# CHANGE ORDER

Project Name: **Haverhill Consentino Middle School** CO No. **20**

Architect's Project No. **21-0818**

See attached list of 7 item(s) for a total of ..... \$ 54,776.41

**DRAWING NUMBER:** M1.22

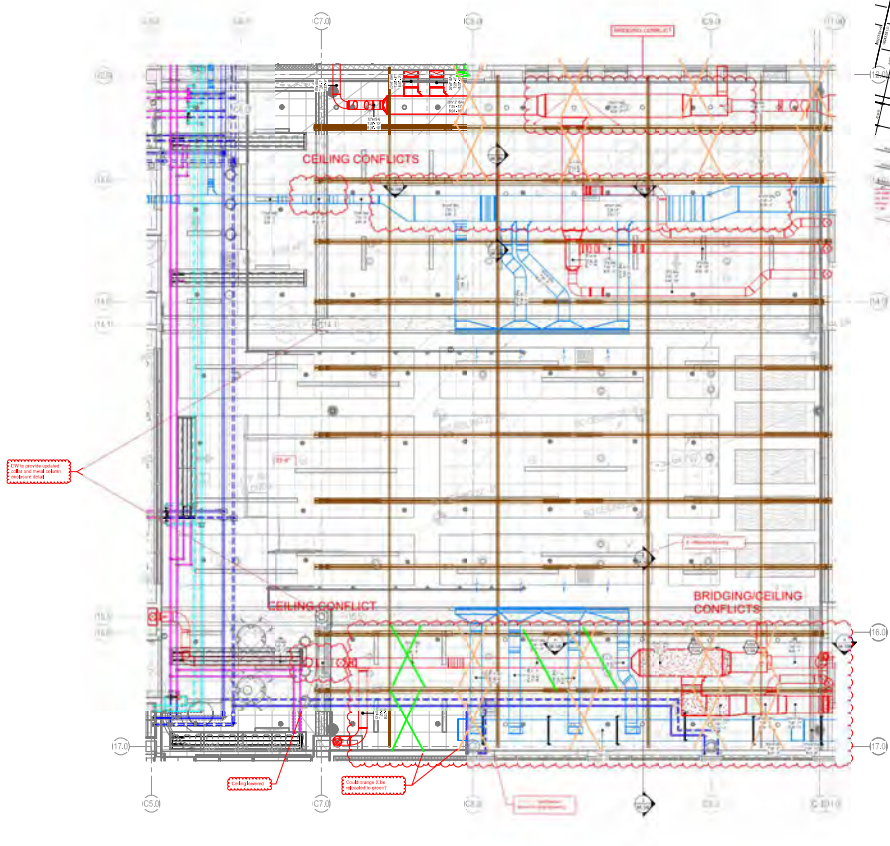
**Question**

There are multiple conflicts with joist bridging and ceilings in the cafeteria.

Refer to attached A2.23 with modified ceiling heights to reflect RFI 167. Please refer to comments on individual sheets. Contractor to incorporate changes and verify with Joist Manufacturer. Contractor to issue RFI 167 R1 once changes are incorporated to determine any remaining conflicts.

Date: 1/26/12  
10:25:29 AM  
Drawn By: TB  
SK.10B  
Scale: 3/8" = 1'-0"

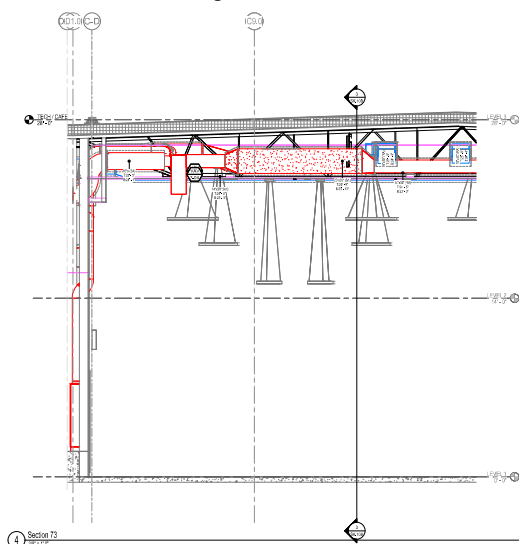
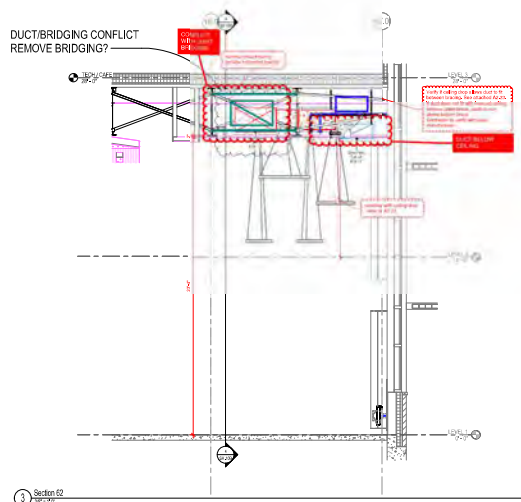
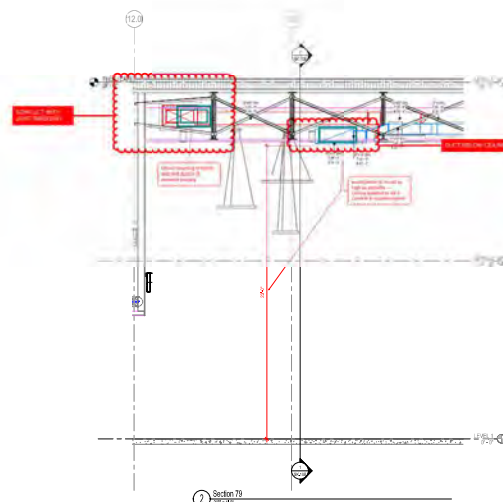
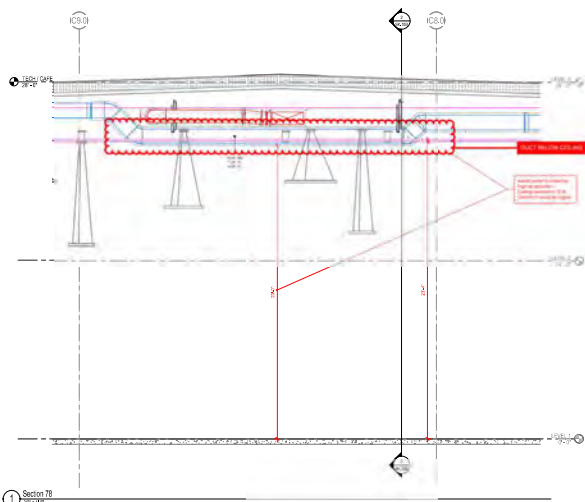
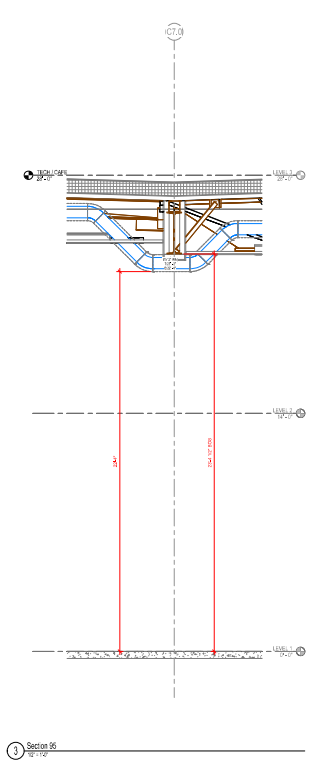
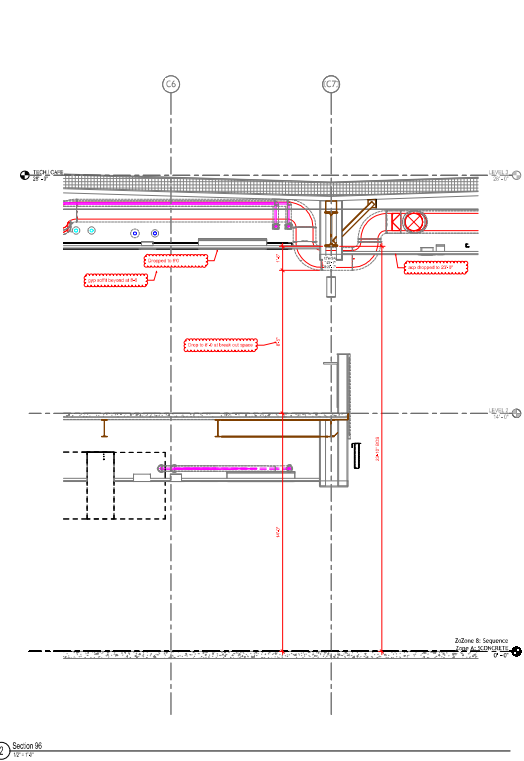
Costs associated with the attached for RFI 167 Joist Bridging Conflicts. Joist bridging in the cafetorium and gym areas required redesign and rework to avoid conflicts with MEP systems, primarily ductwork.

## JD-142

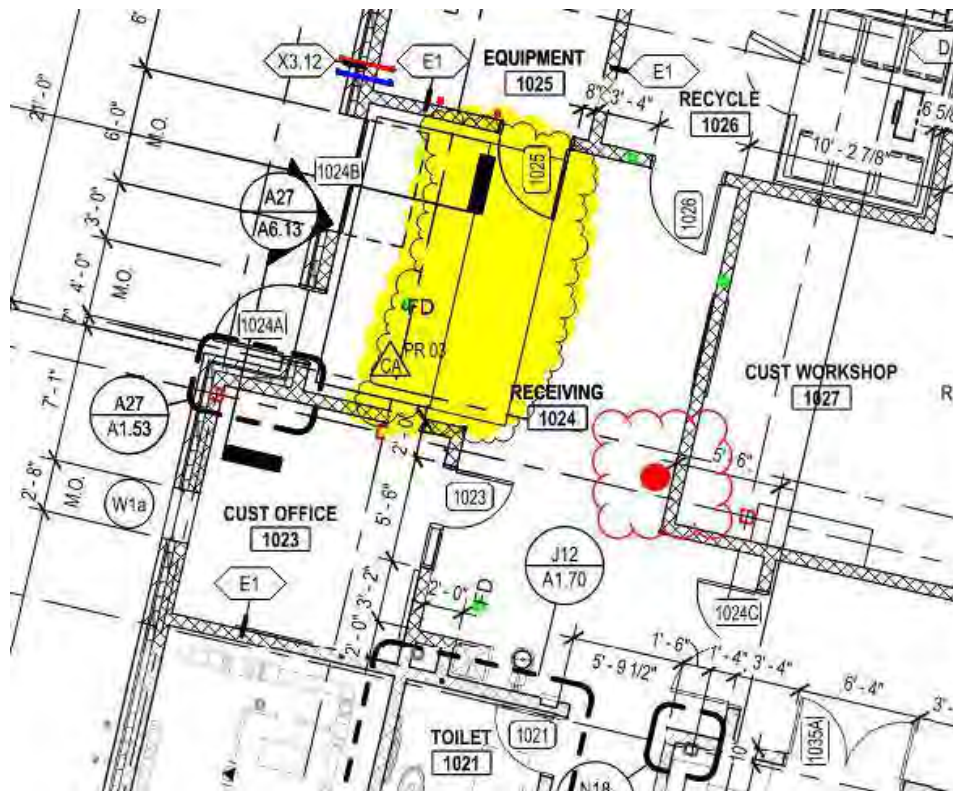
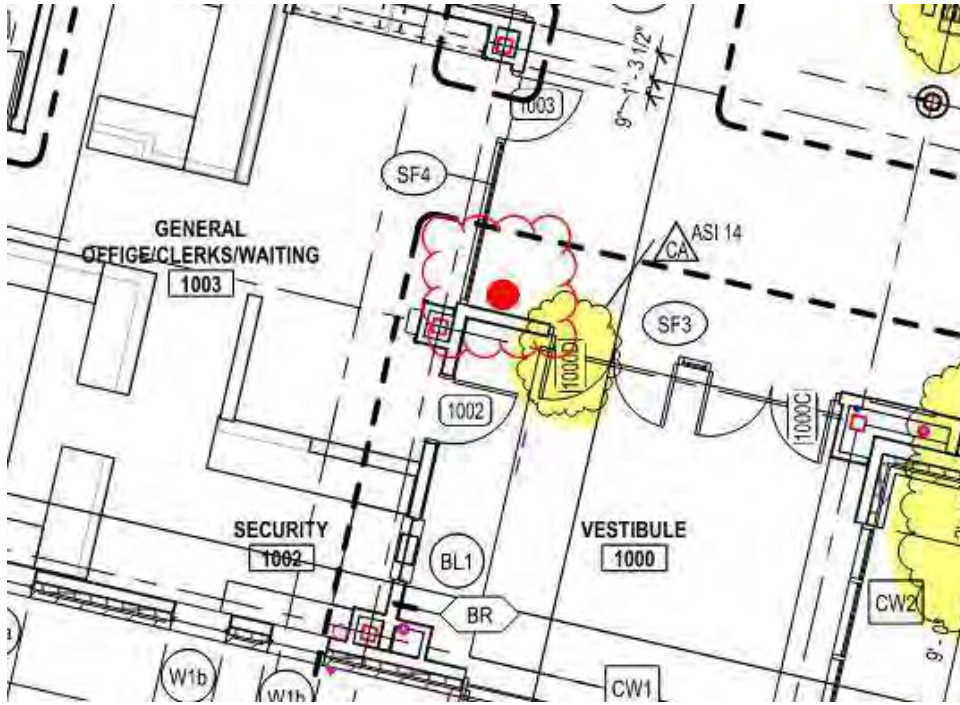
Time clock network connections: Furnish and install a single Cat 6A cable from the MDF to each of the two locations indicated with a red dot. Coordinate the exact requirements at each location and in the MDF with the installer of the timeclocks. Test, label and document on the official set of as-built plans. Refer to **JD-142**.

Owner to provide cut sheet of time clock to contractor for installation. Contractor to provide blocking as required.

## RFI #269: CMS - RFI 269 - Detention System #1

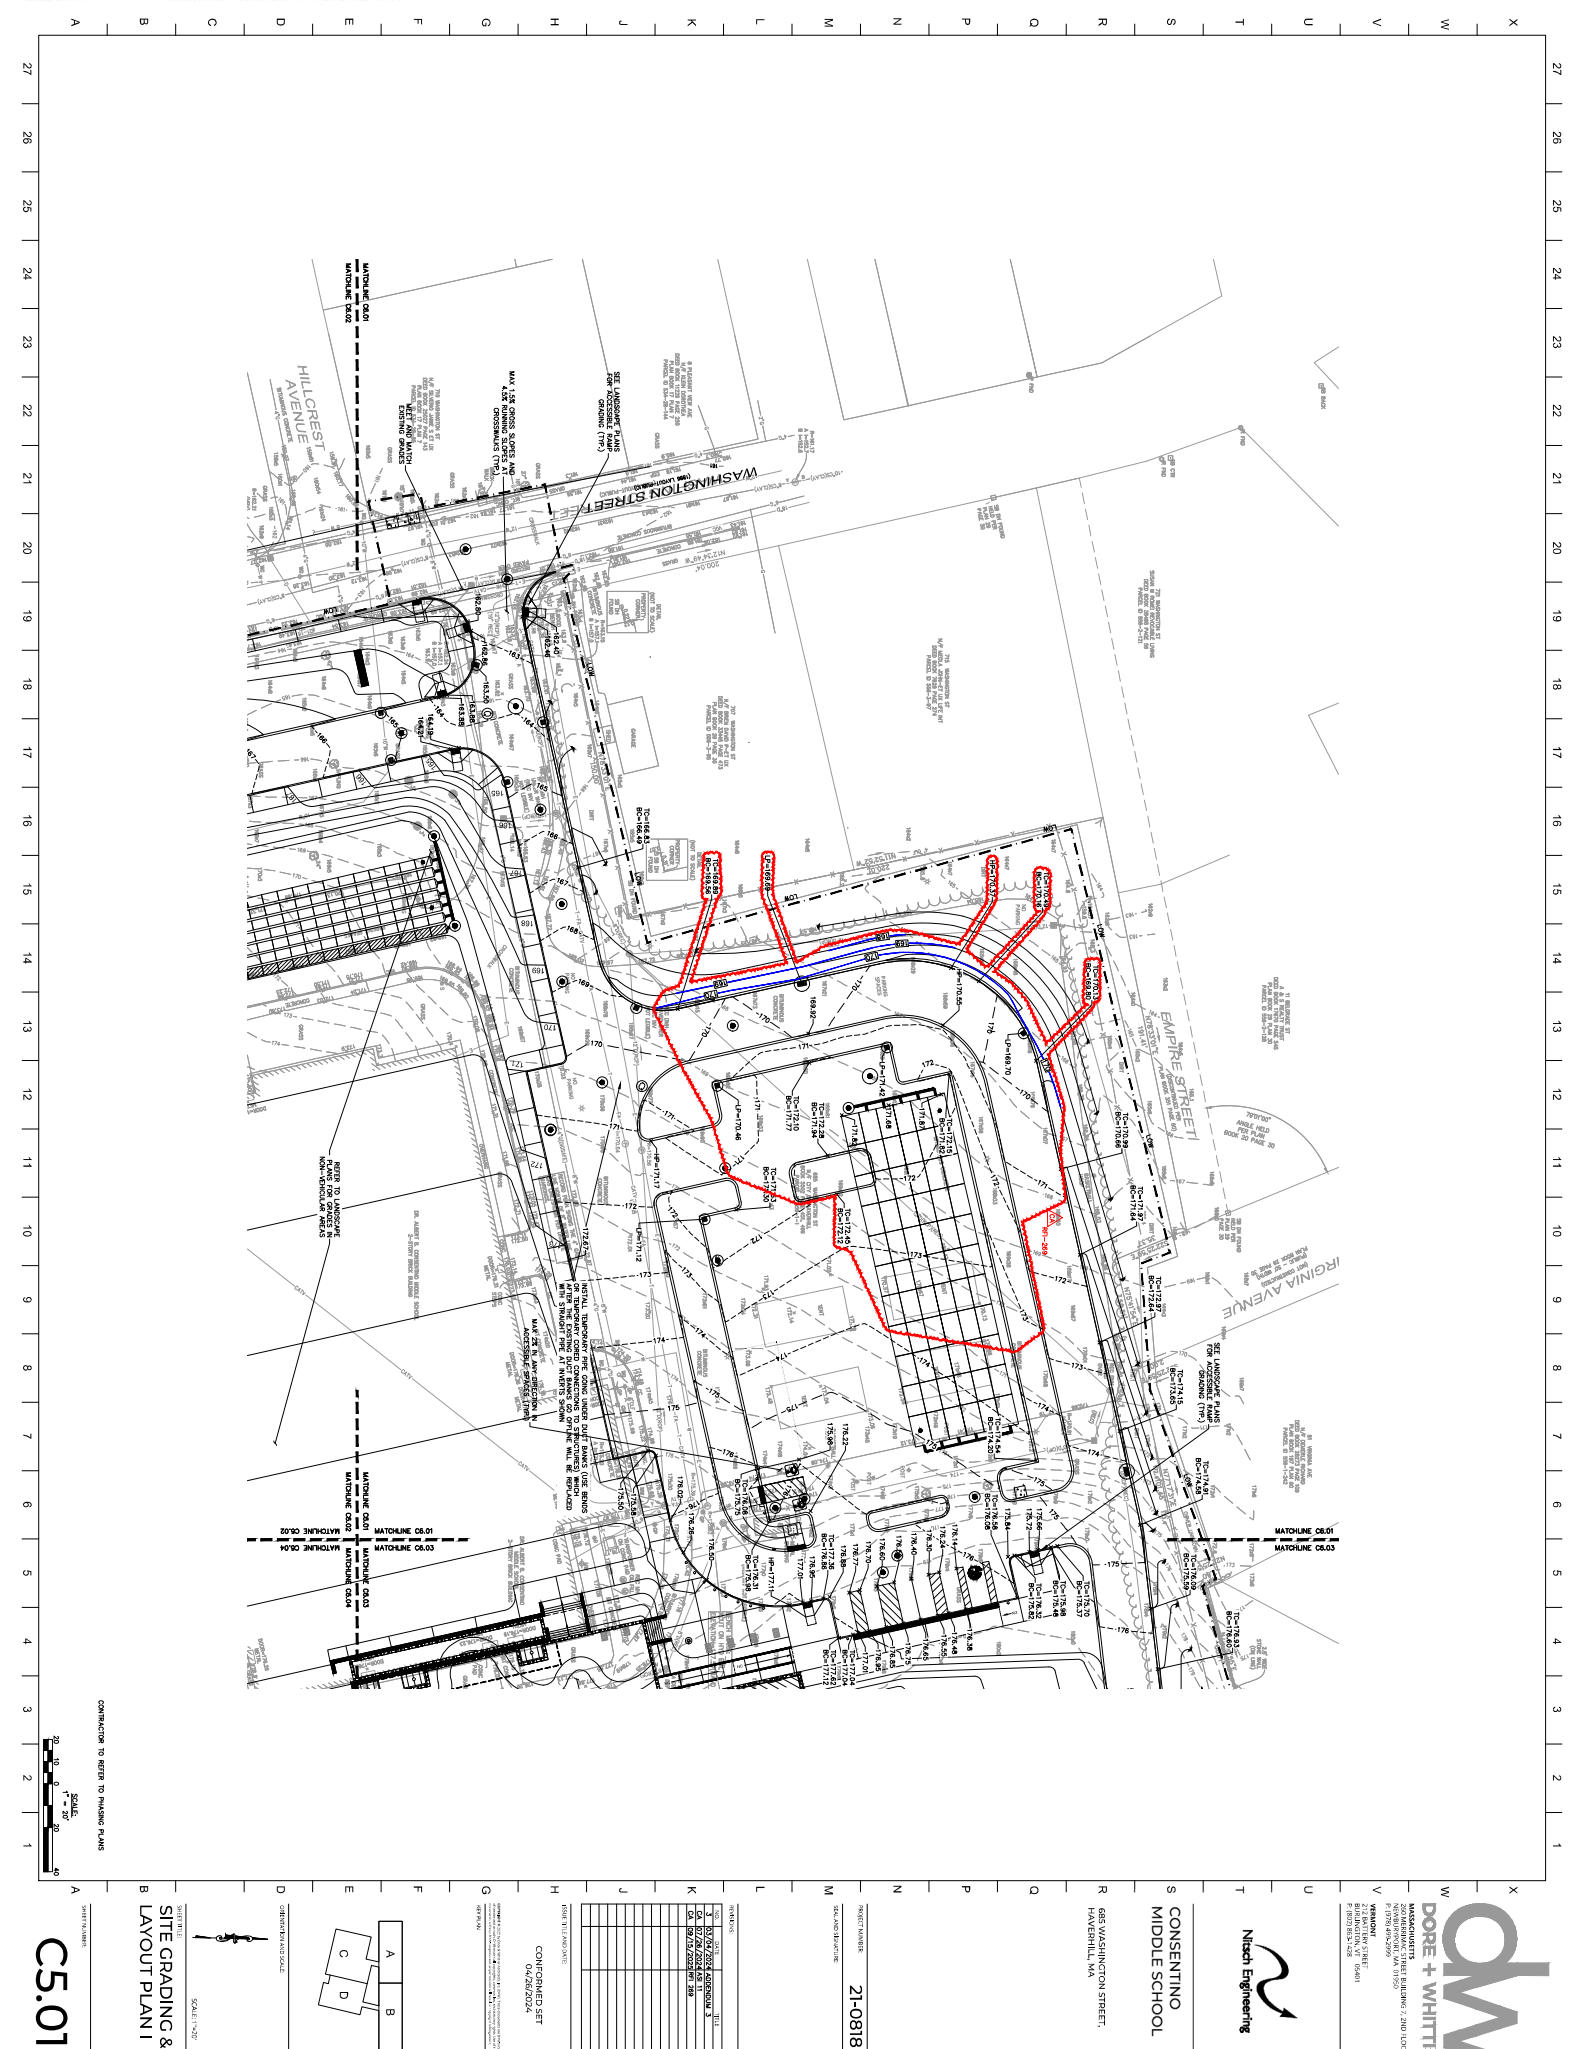
On the West end of detention system#1 there is 6 to 9 inches of difference between finish elevation of asphalt and top of concrete chamber. We are not able to get the correct amount of select gravels underneath asphalt.

Please see revised sheets (3) depicting grading changes to adjust cover over the system. Note that the weir should be removed from the OCS as well.
